ADDENDUM NO. 2

RE: LIGHTING & FURNACE REPLACEMENT
Knox County Housing Authority
Galesburg, Illinois

DATE: April 19, 2024

WOODLAND BEND SITE PLAN
 SCALE: 1" = 40'-0" 480 IOWA AVENUE

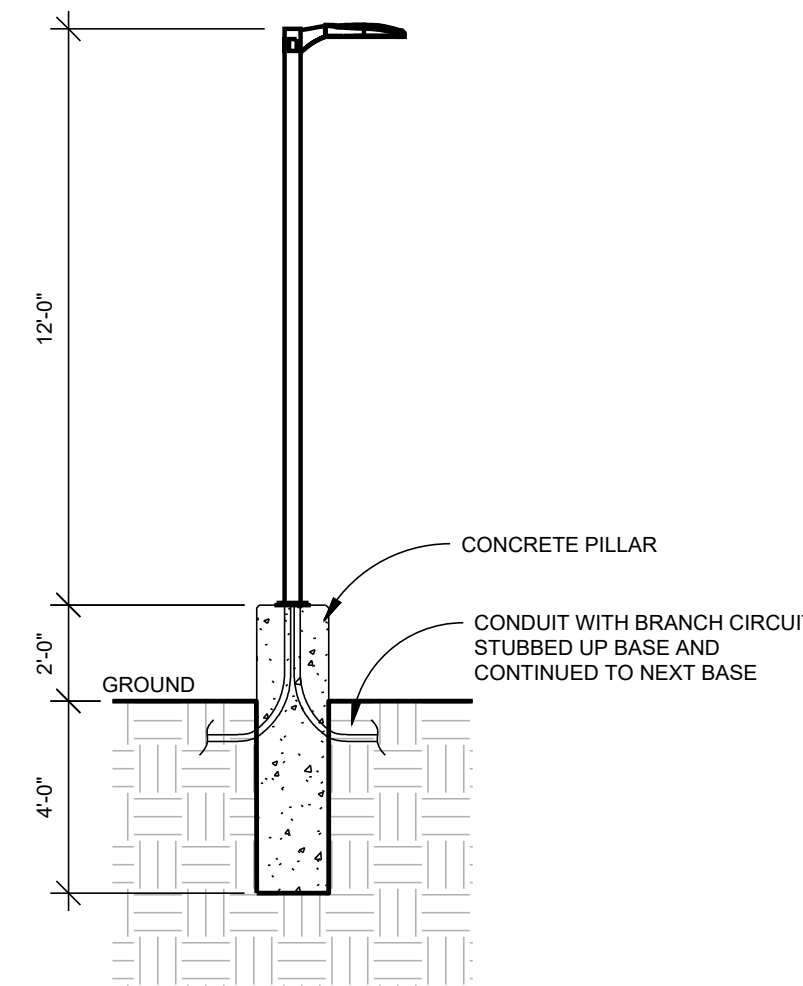
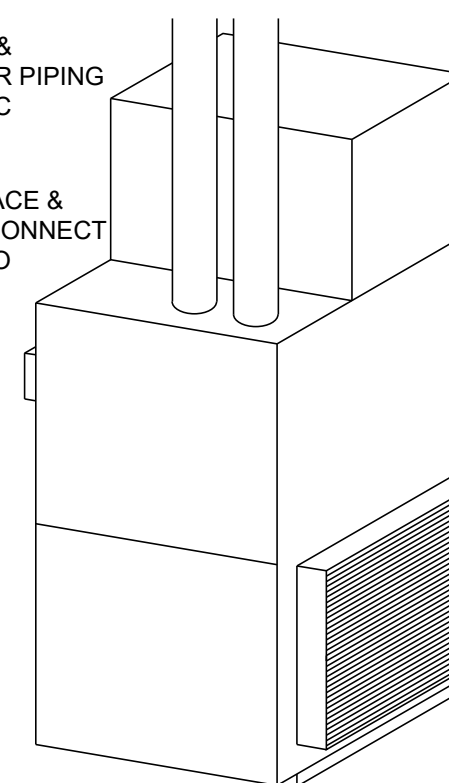
6. **SPECIFICATIONS**; 23 81 26 .13 SMALL CAPACITY SPLIT-SYSTEM AIR CONDITIONERS; **2.04 OUTDOOR UNITS**; **B** should read as follows:
- B. Compressor: Scroll ,3600 rpm, AHRI 520 resiliently mounted integral with condenser,with positive lubrication, high-pressure control, motor overload protection, service valves and drier. Provide time delay control to prevent short cycling.
7. **DRAWINGS**; Sheet No. 2 (Revised and Reissued dated 4/19/24); CONDENSING UNIT SCHEDULE; NOTES: has been updated; see attached.
8. **DRAWINGS**; Sheet No. 2 (Revised and Reissued dated 4/19/24); ELECTRICAL NOTES has been updated; see attached.
9. **DRAWINGS**; Sheet No. 10 (Revised and Reissued dated 4/19/24); has been updated; see attached.
